DTC (Code) P0402 - 00 Codigo:	Bulletin: RD18-002 Date Fecha: August 12, 2018
Description:	Engine Exhaust Gas Recirculation Differential Pressure - Mechanical system not responding properly
Application:	US13 – US20 Emissions

EGR Differential Pressure Sensor, Replacement

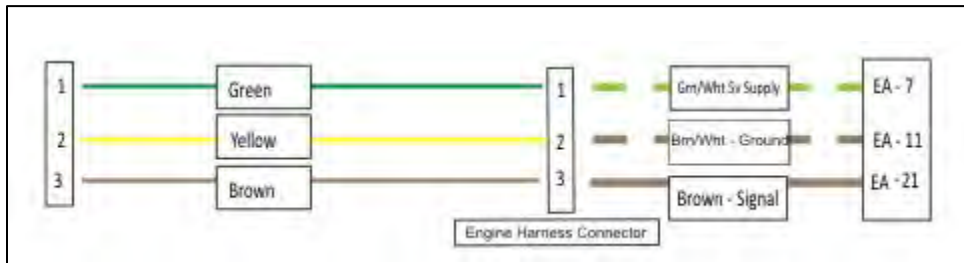
Note: When installing the kit for the updated EGR differential pressure sensor for the D13 engine, the engine harness connector pins will need to be relocated. The previous pin locations were:

- Pin 1 — Green/White
- Pin 2 — Brown
- Pin 4 — White/Brown

Note: The new engine harness connector pin locations when replacing old style EGR differential pressure sensor with the new style sensor in kit are:

- Pin 1 — Green/White
- Pin 2 — Brown/White
- Pin 3 — Brown
